3/31/09	Added General Note (F)
DATE	REVISION	
STATE OF HAWAII DEPARTMENT OF TRANSPORTATION HIGHWAYS DIVISION BRIDGE GENERAL NOTES INTERSTATE ROUTE H-1 EXTENSION AND REPAIR OF SCHOOL STREET ON-RAMP RETAINING WALL Project No. H11-01-08 Scale: As Noted Date: Feb., 2009

3/31/09	Revised and/or Added Callouts and Legend
DATE	REVISION
STATE OF HAWAII DEPARTMENT OF TRANSPORTATION HIGHWAYS DIVISION RETAINING WALL REPAIR and EXTENSION EXISTING SITE PLAN INTERSTATE ROUTE H-1 EXTENSION and REPAIR of SCHOOL STREET ON-RAMP RETAINING WALL Project No. H11-01-08	
Scale: As Noted	Date: Feb, 2009
SHEET No. Q3 OF 34 SHEETS

RETAINING WALL REPAIR and EXTENSION

LILIHA SEPARATION ABUT NO. 2
END POST UPGRADE

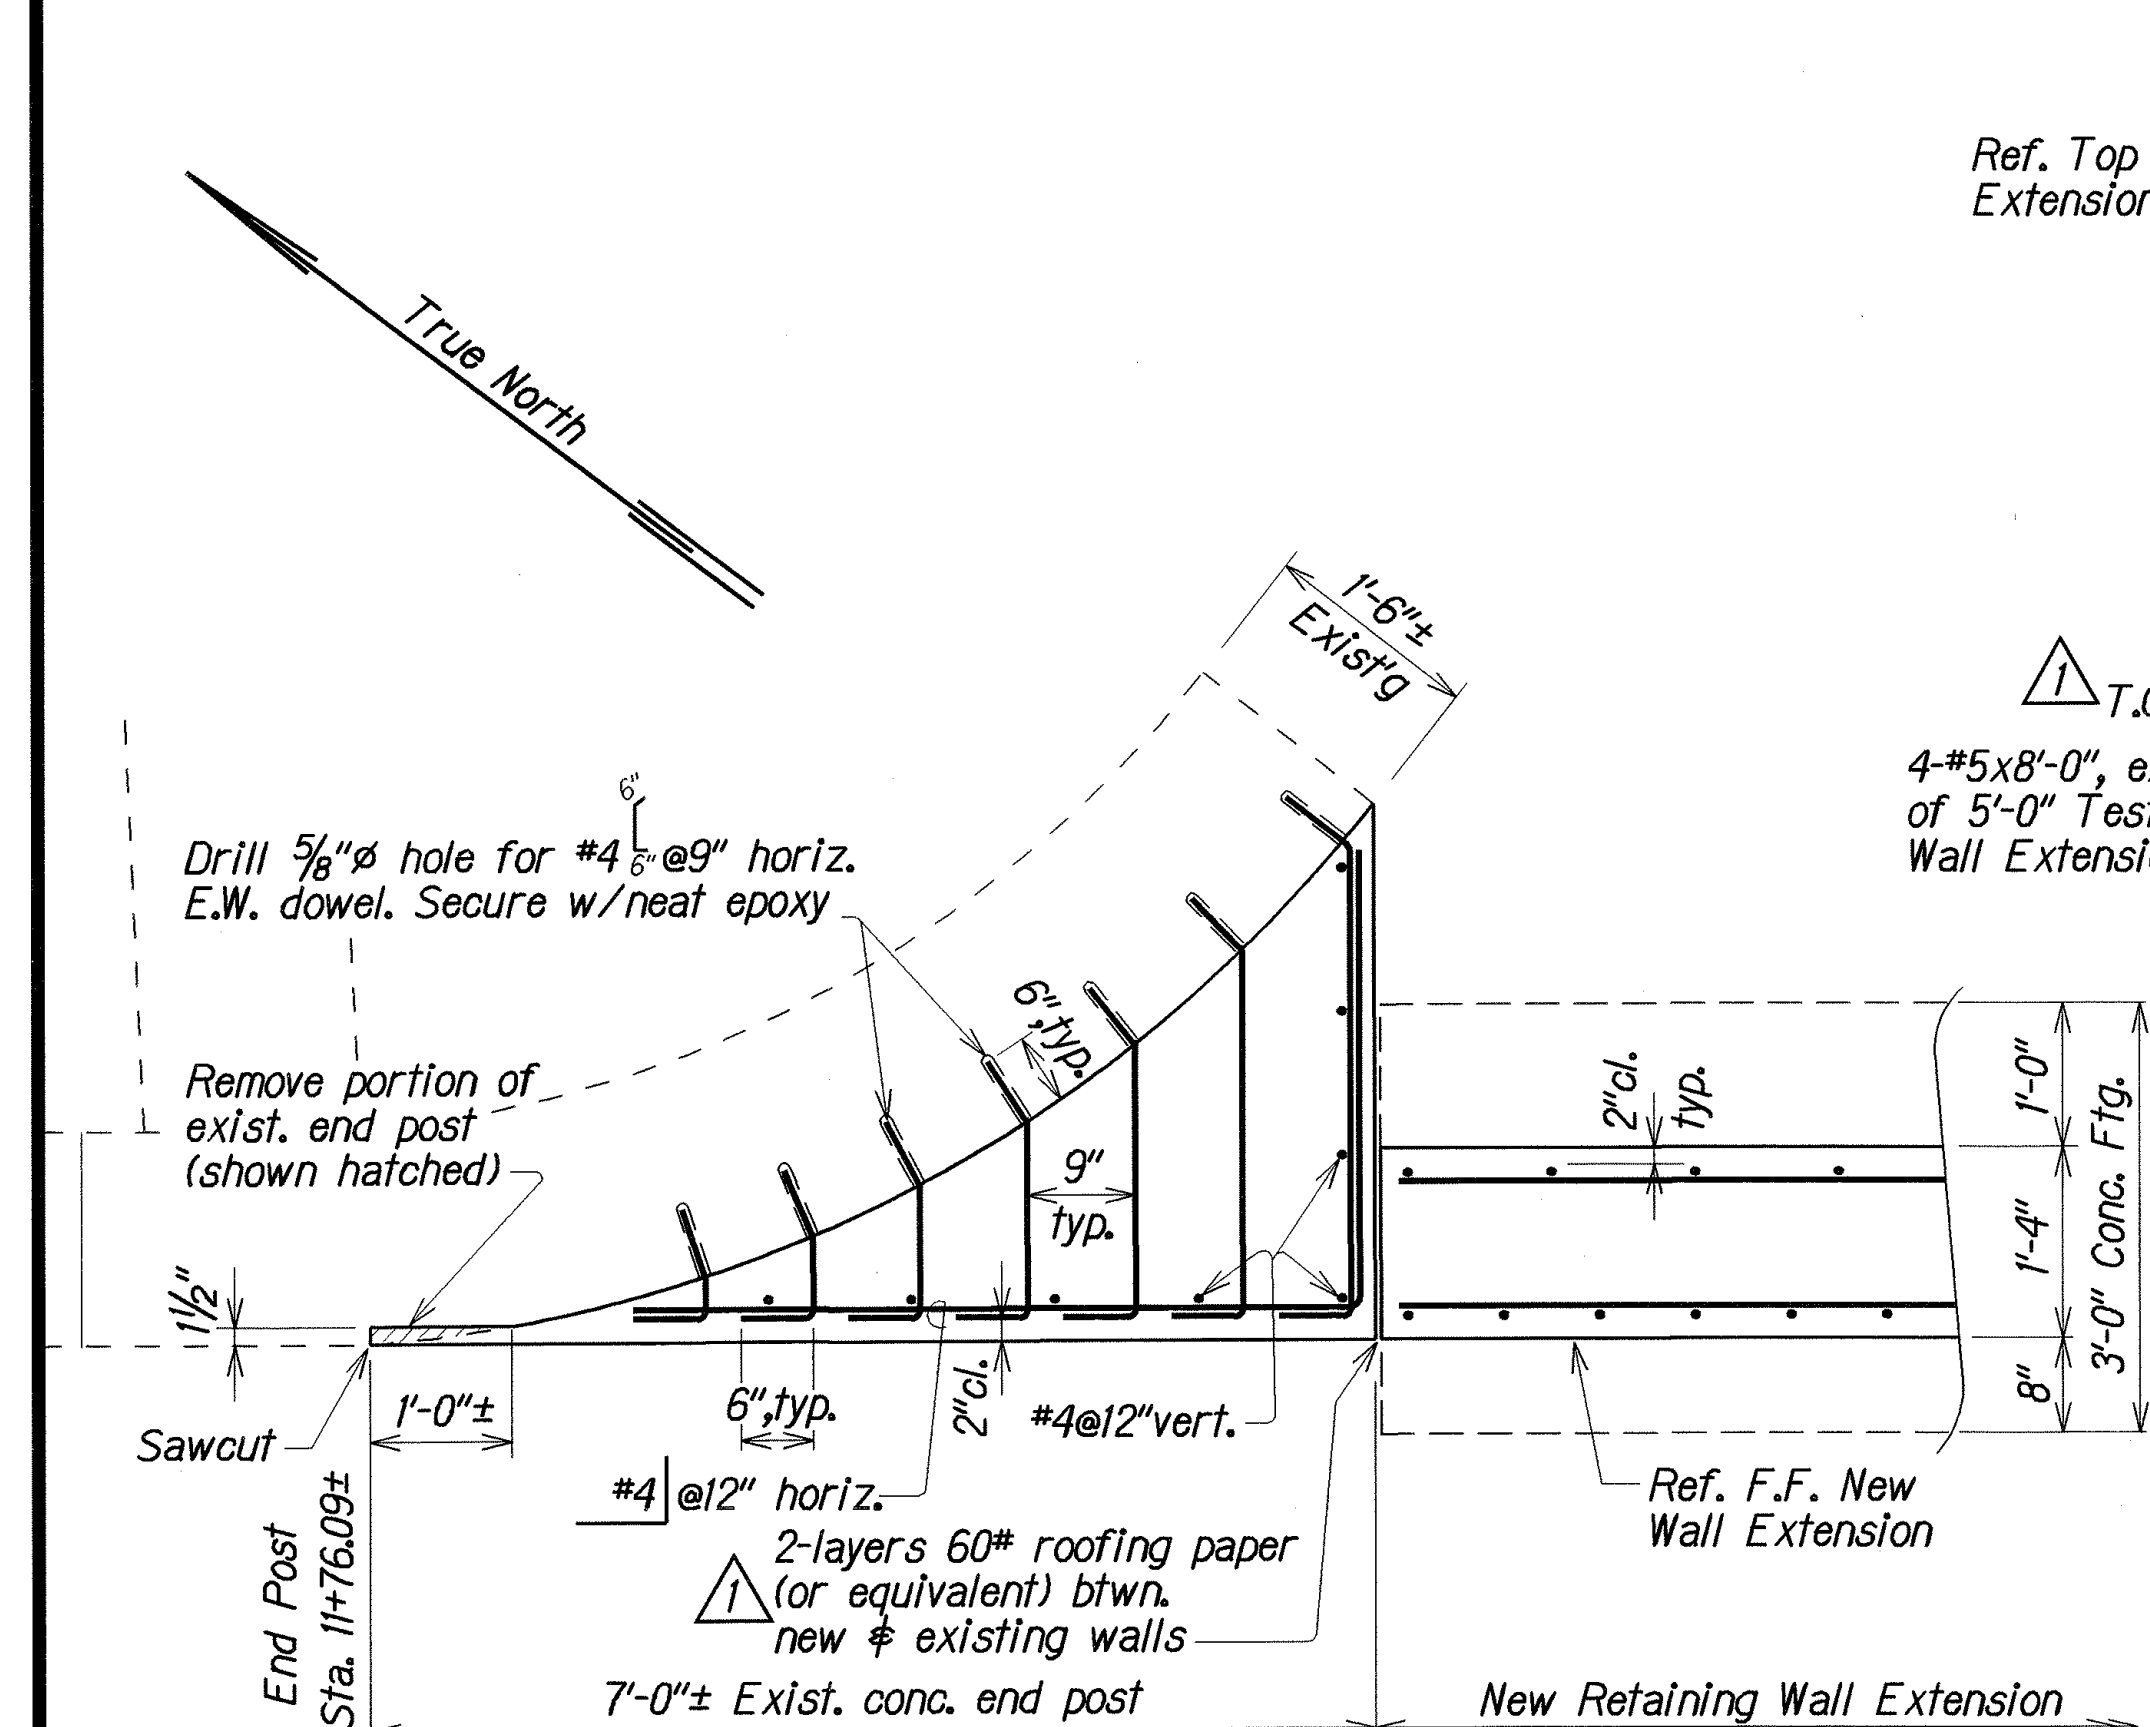
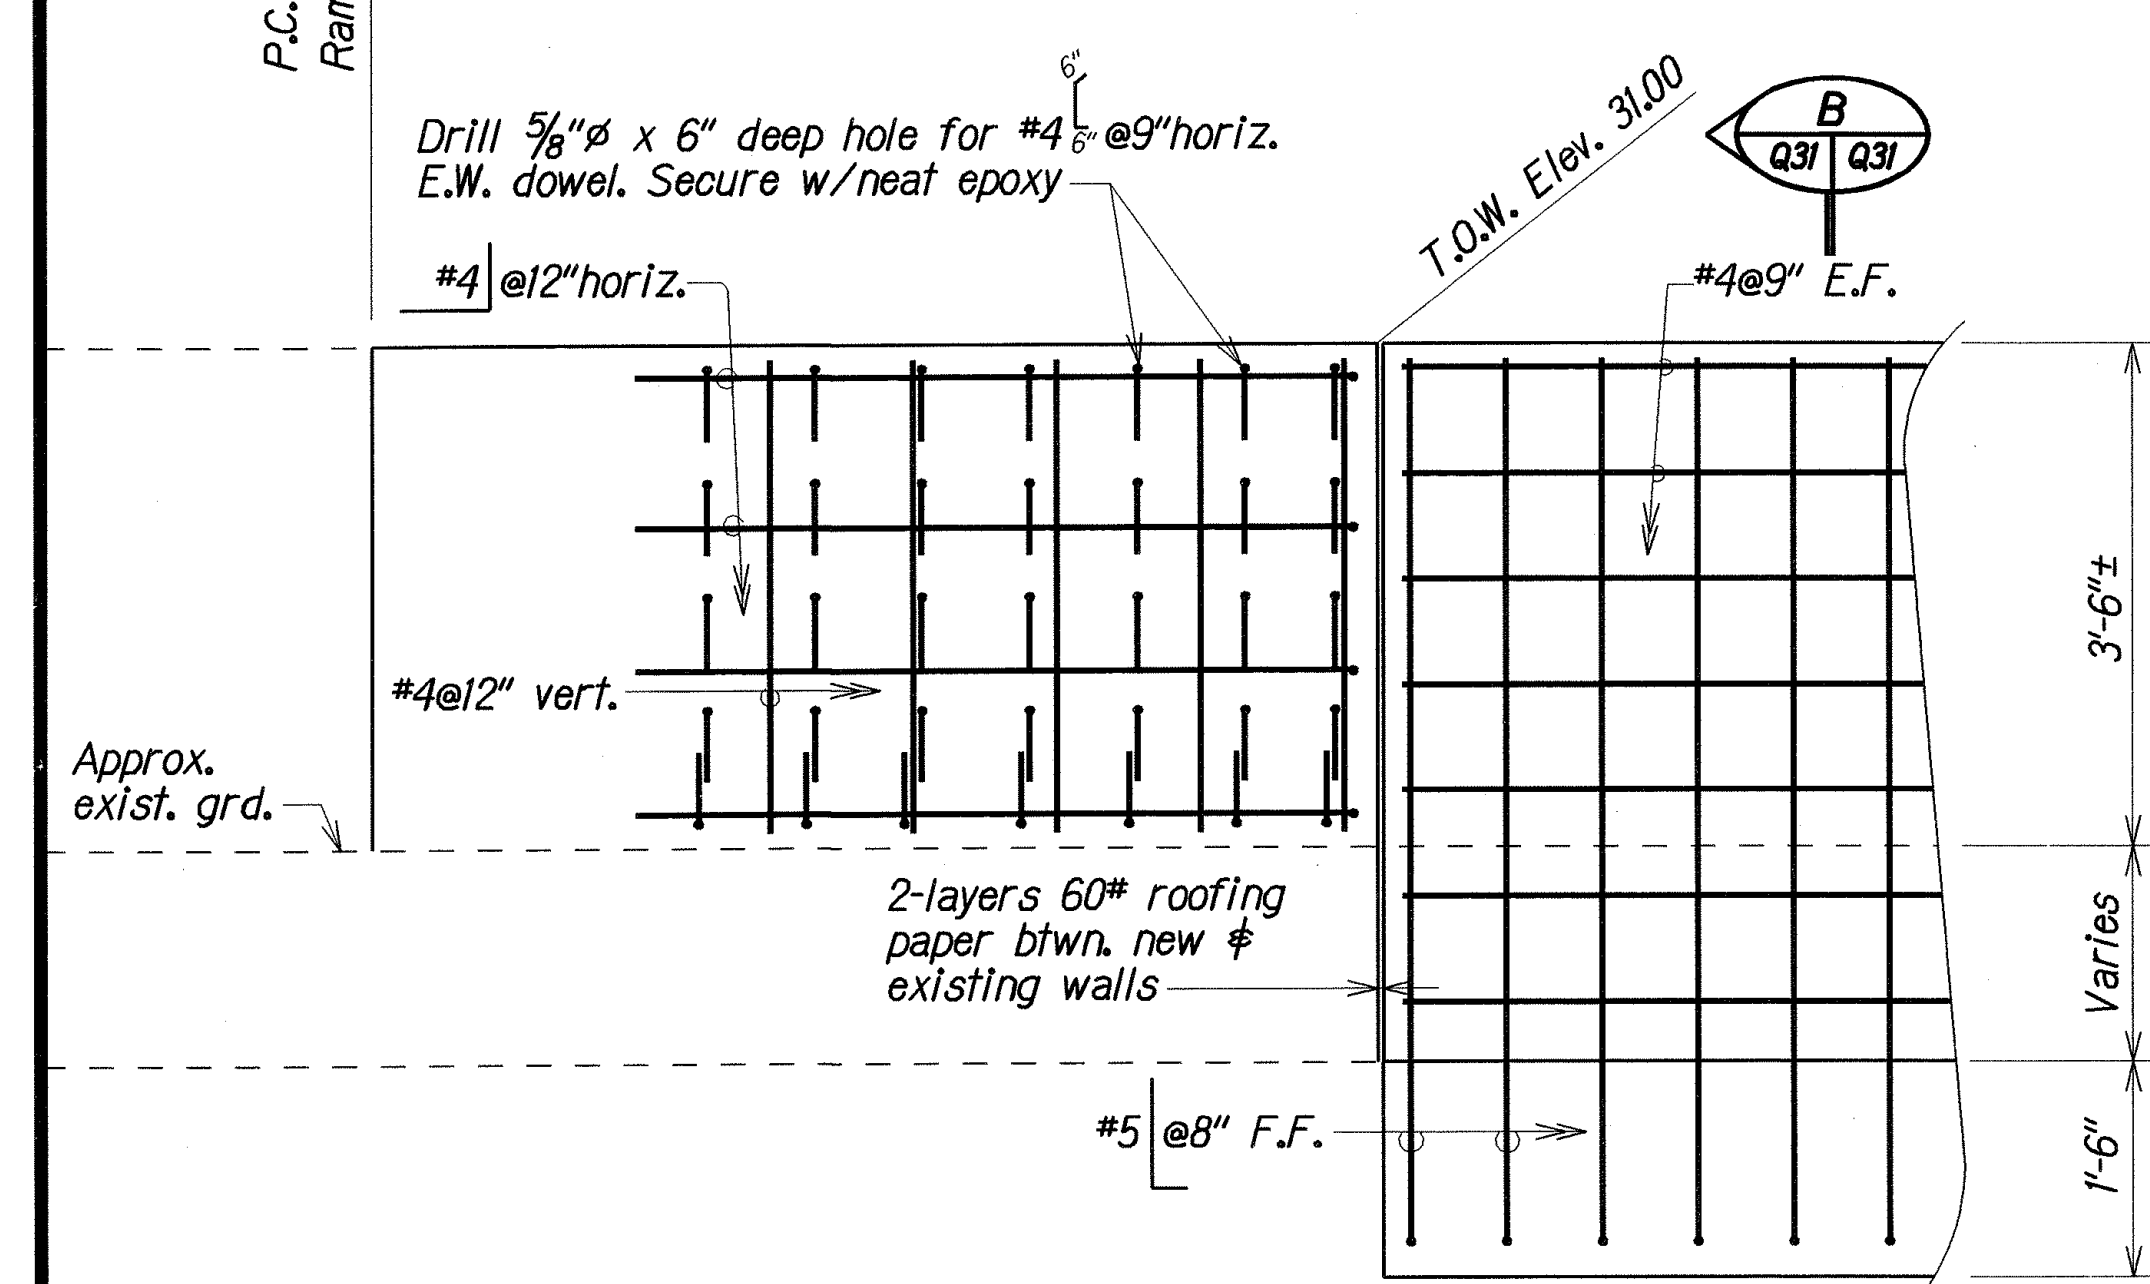
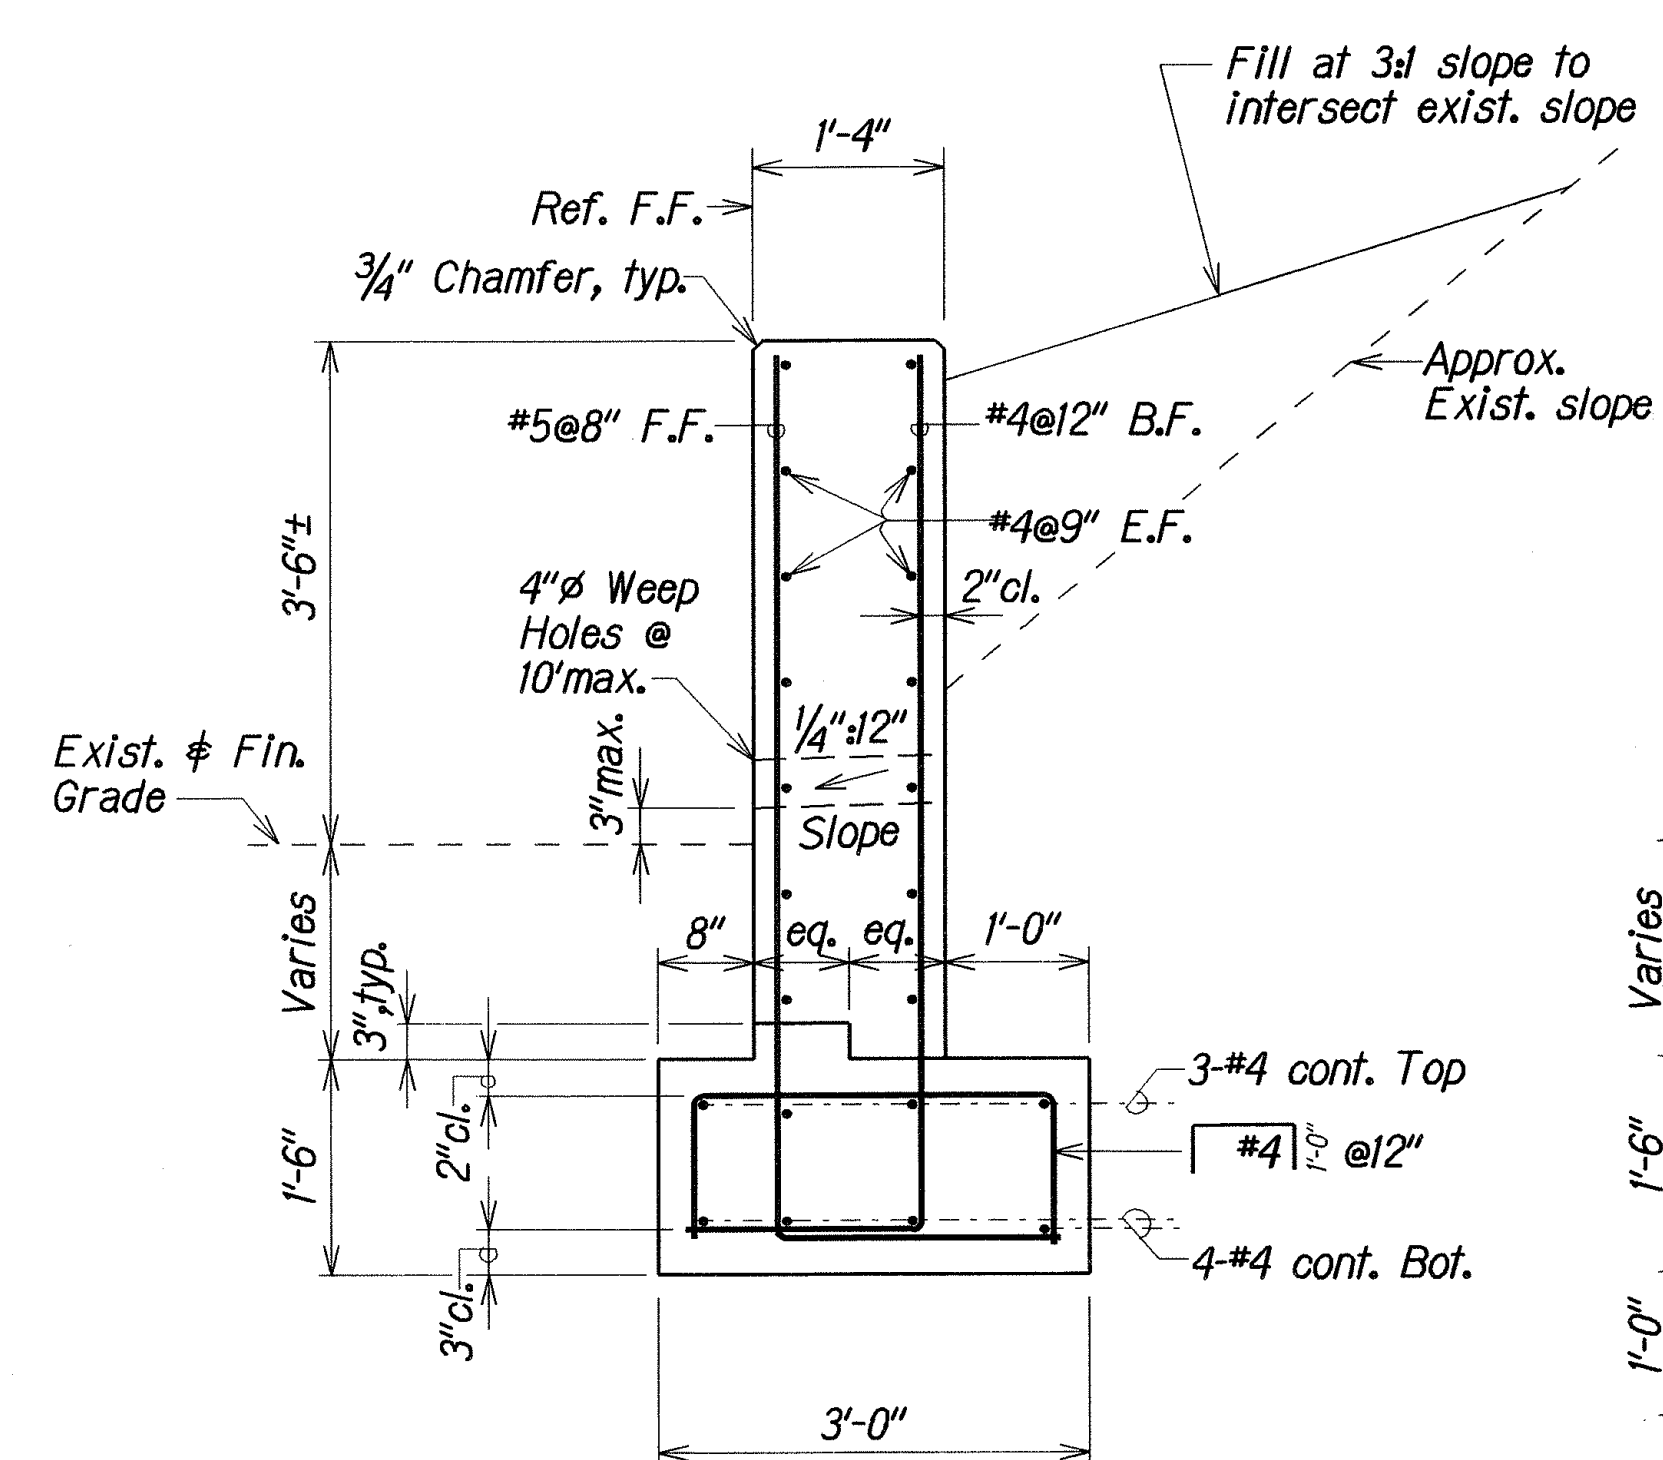
DATE	DESCRIPTION
3/31/09	Added & Modified Callouts for Details and Added Section Sheet Numbers.
STATE OF HAWAII DEPARTMENT OF TRANSPORTATION HIGHWAYS DIVISION RETAINING WALL EXTENSION LILIHA SEPARATION ABUTMENT NO. 2 UPGRADE and TYPICAL RETAINING WALL EXTENSION DETAILS INTERSTATE ROUTE H-11 EXTENSION and REPAIR of SCHOOL STREET ON RAMP RETAINING WALL Project No. H11-01-08 Scale: As Noted Date: Feb. 2009	
SHEET No. Q31 OF 34 SHEETS
